Re: Comment and Request by Kurt A. Fisher (“Applicant”) for Determination that the Proposed 4th Avenue Well Chlorination Project at approximately 400 North Canyon Road, Salt Lake City, Utah (the “Well”)² is a “High Risk Facility” pursuant to Federal Chemical Facility Anti-Terrorism Standards (6 C.F.R. § 27.203 and 205).

First, this letter is a Salt Lake City Corporation (the “City”) level comment on the concept design of the proposed Well by the Salt Lake City Department of Public Utilities (“DPU”) at approximately 400 North Canyon Road in Salt Lake City.³ Second, this letter is a request to the United States Department of Homeland Security (“DHS”) (a) to conduct a preliminary security risk assessment into whether the DPU and the City have complied with chemical facility anti-terrorism standards for critical infrastructure facilities⁴ when designing the Well and (b) to issue a determination on whether the facility, given its overall characteristics as described below, is a presumptively high risk facility.⁵

Figure 1 – Schematic of Applicant's Proposed Option B Design near 61 East North Temple. Compare to DPU Architectural Renderings in Figure 3 and Figure 4, below.

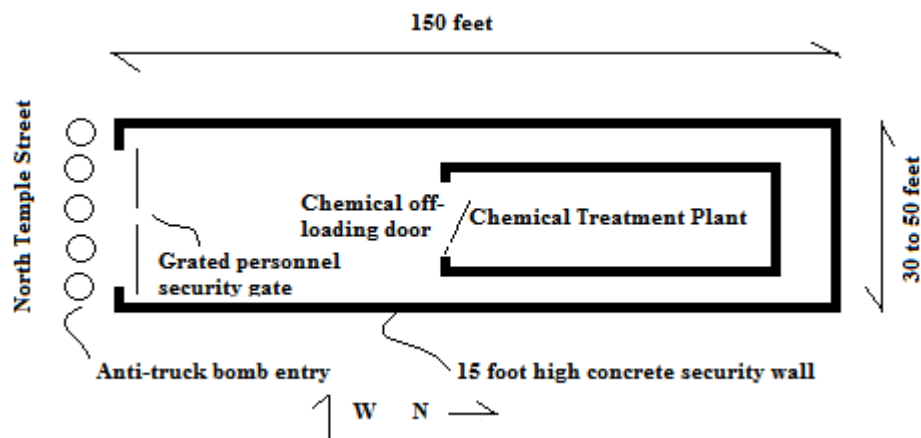
Option 6: Your applicant believes that once informed with the potential for a plausible terrorist attack on the DPU proposed Well design, described below, that the Church of Jesus Christ of Latter Day Saints would be willing to donate land at the west end of a vacant lot at the northwest corner of the nearby intersection of State and North Temple Streets¹³ for a more terrorist resistant chemical facility. The Church's Worldwide Headquarters that offices over 1,000 persons is across the street and is within one-quarter mile of the DPU's proposed chemical treatment facility. In this option, a water transmission line would be constructed from the existing wellhead to the new site. A utilitarian concrete structure similar in foot print to the DPU's current design, would be surrounded by a 15 feet tall steel re-enforced concrete wall. Street access for sodium hydrochlorite deliveries would be from North Temple Street via an anti-truck bomb resistance entry. A similar anti-truck bomb resistant entry is used at the cash delivery bay at the Federal Reserve Bank at the southwest corner of 100 South and State Street, Salt Lake City. At the Federal Reserve Bank, electrically driven subsurface posts are normally extended upward and are only lowered when armored car deliveries occur. The following figure shows a schematic of this Applicant proposed alternative:

In this option, the chemical treatment facility would also be hardened to survive an expected magnitude 7.0 earthquake without releasing sodium hypochlorite.
